Proposed Change 1882

Code Reference(s):	NBC20 Div.B 3.8. (first printing)
Subject:	Accessibility, Visitability and Adaptability of Dwelling Units
Title:	Reinforcing Stud Walls in Washrooms for the Future Installation of Grab Bars: Showers and Bathtubs
Description:	This proposed change introduces requirements to reinforce stud walls around showers and bathtubs in dwelling units for the future installation of grab bars.
Related Proposed Change(s):	PCF 1884, PCF 1958, PCF 2030, PCF 2031

Figure [A-3.8.4.3.(2) and (4)-A]
Example of an acceptable configuration for the reinforcement of the side wall and entrance wall⁽¹⁾ of a shower

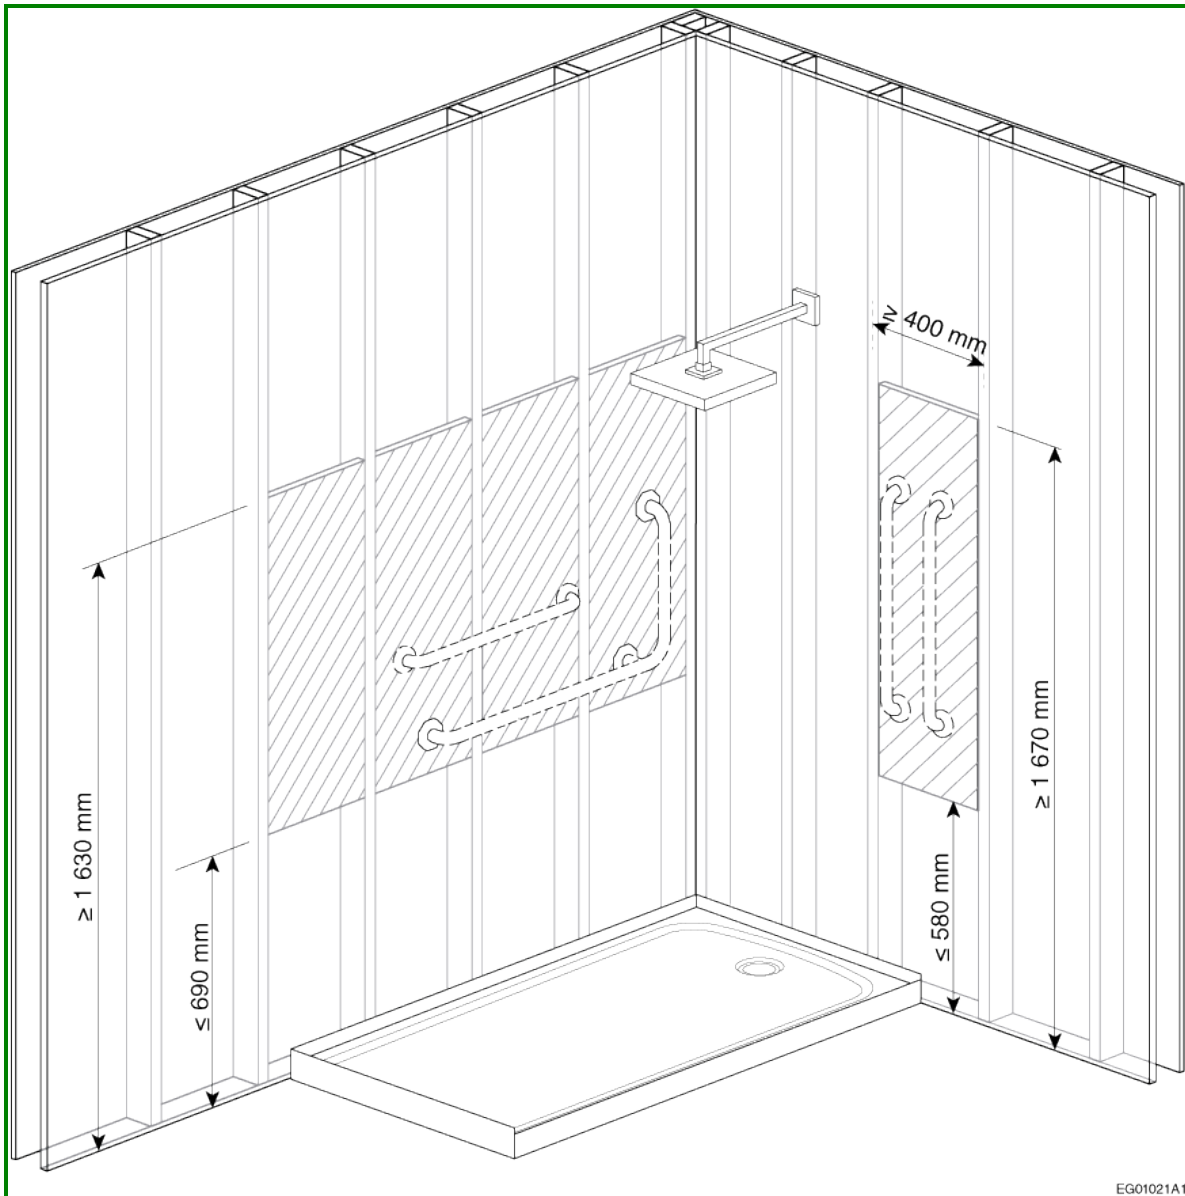
[a] --) on side walls, extends horizontally along the full length of the shower and vertically from 690 mm to 1 630 mm above the finished floor, and

[b] --) on entrance walls, extends horizontally at least 400 mm, centred over the shower entrance, and vertically from 580 mm to 1 670 mm

Figure [A-3.8.4.3.(2) and (4)-B]
Example of an acceptable configuration for the reinforcement of the side wall and entrance wall⁽¹⁾ of a bathtub or bathtub/shower combination

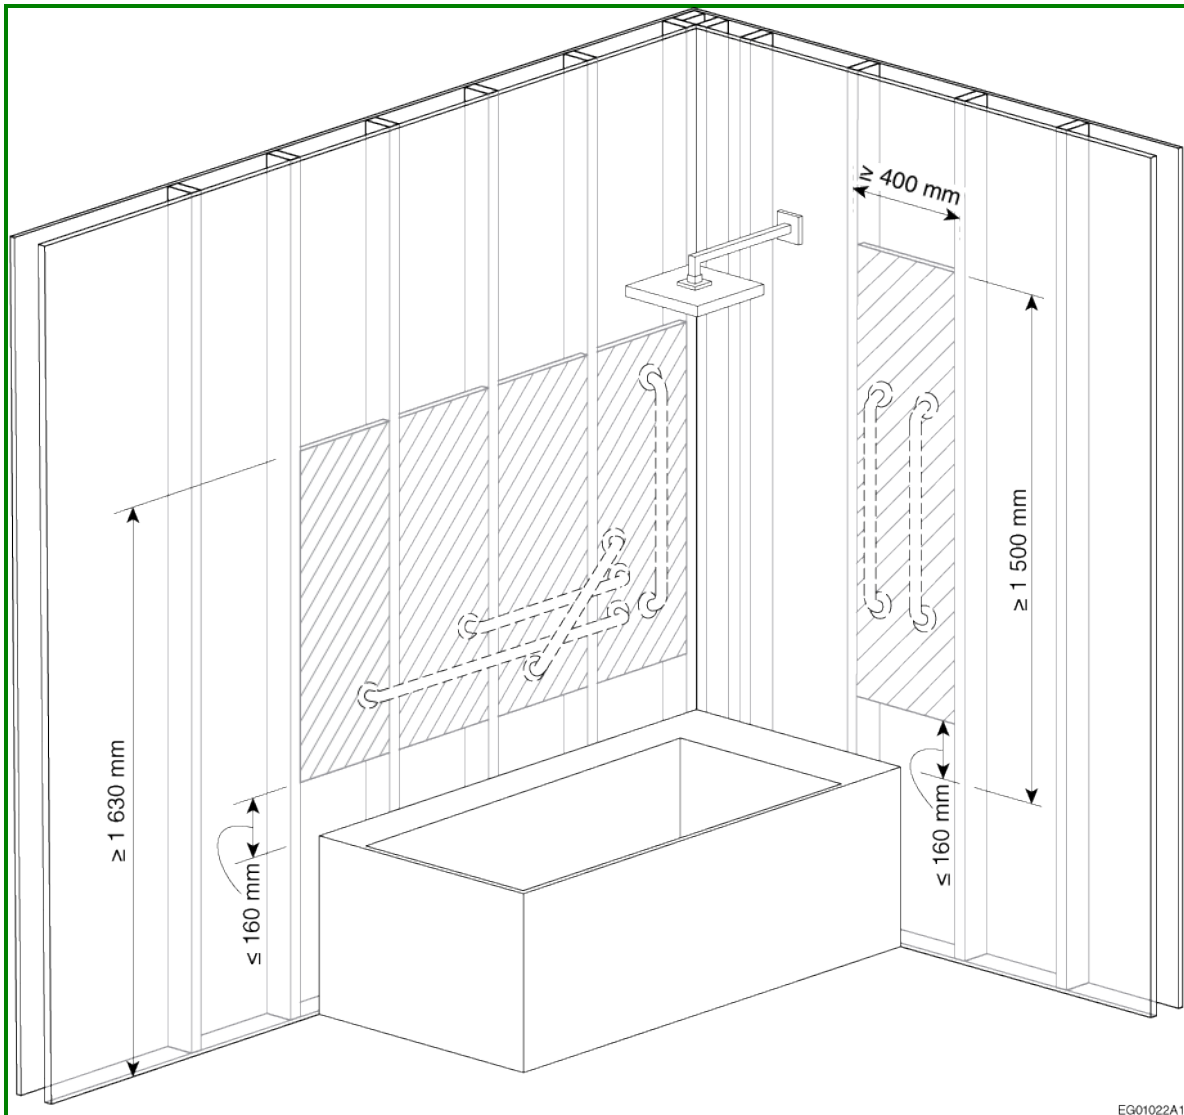
[a] --) on side walls, extends horizontally along the full length of the bathtub or bathtub/shower combination and vertically from 160 mm above the bathtub rim or tiling flange to 1630 mm above the finished floor, and

[b] --) on entrance walls, extends horizontally at least 400 mm, centred over the bathtub or bathtub/shower combination entrance, and vertically from 160 mm to 1 500 mm above the bathtub rim or tiling flange.

Figure [A-3.8.4.3.(5)-A]
Example of an acceptable configuration for the reinforcement of the entrance wall of a shower provided with a prefabricated enclosure

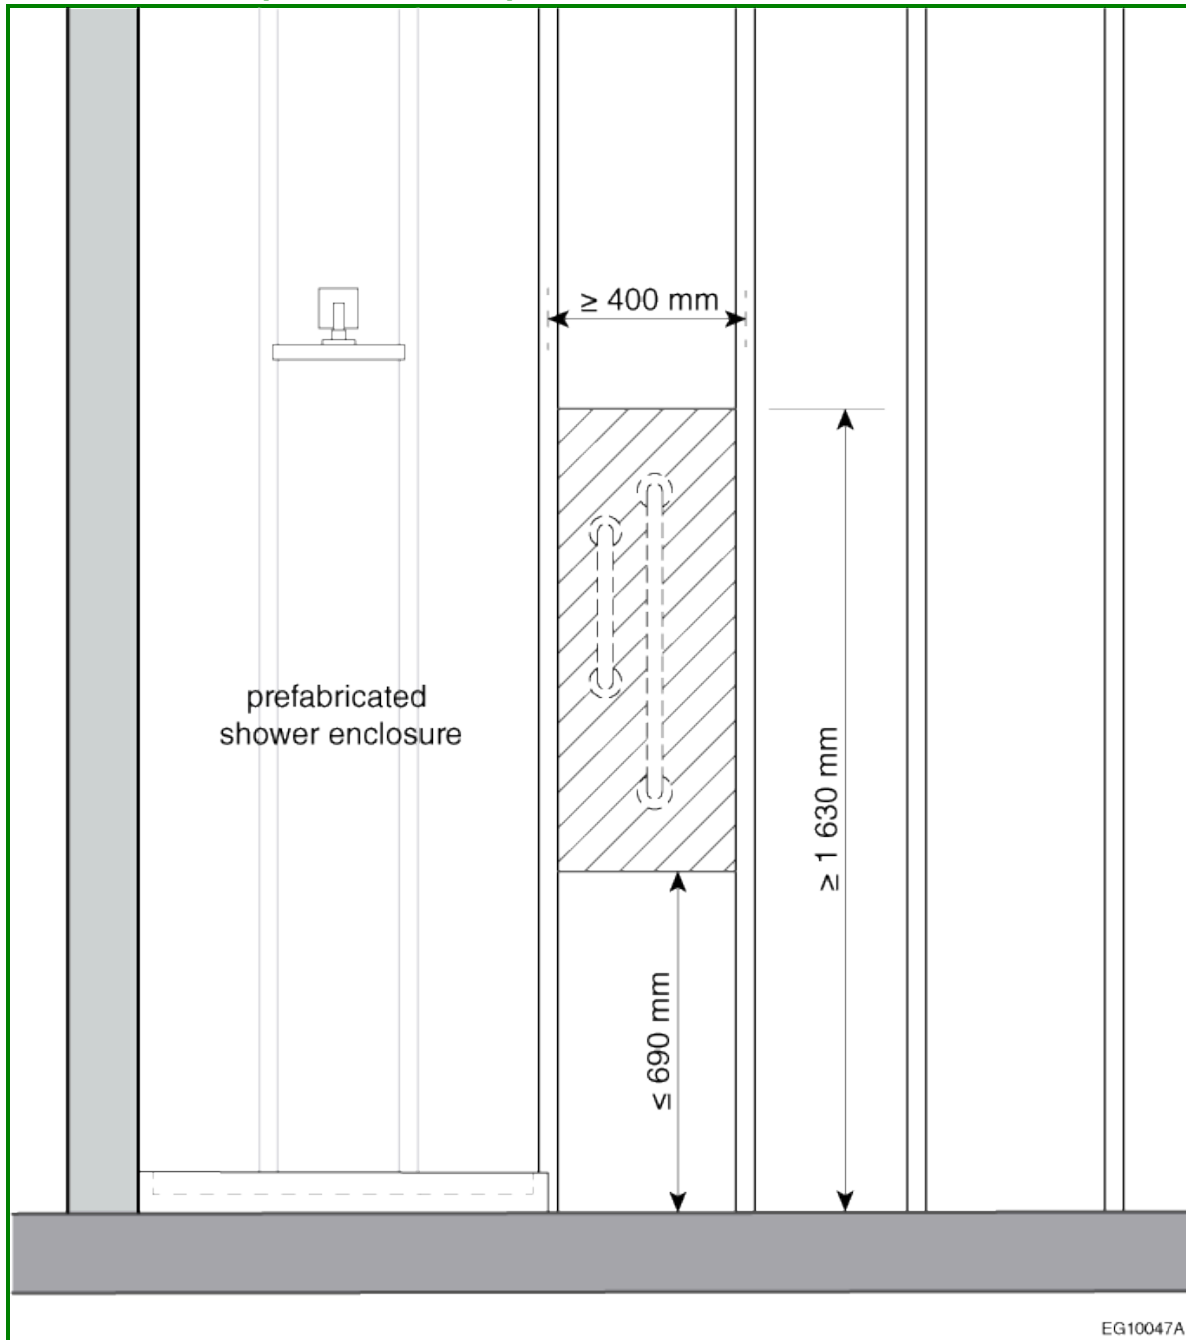
[b] --) Clauses 2(b) and 4(b) apply, except that the minimum reinforcement area shall extend horizontally from the entrance or rim to 400 mm beyond the entrance.

Showers, bathtubs and bathtub/shower combinations provided with prefabricated enclosures are partially exempted from Sentences 3.8.4.3.(2) and (4), as these enclosures are often not compatible with grab bars that are not fabricated as part of the enclosure. To permit grab bars to be installed near the entrance of these enclosures, the minimum reinforcement area is shifted so that it does not overlap with the prefabricated enclosure. Figures 3.8.4.3.(5)-A and -B illustrate examples of acceptable configurations for the reinforcement of stud walls around prefabricated enclosures. Possible configurations of grab bars with different lengths are also shown.
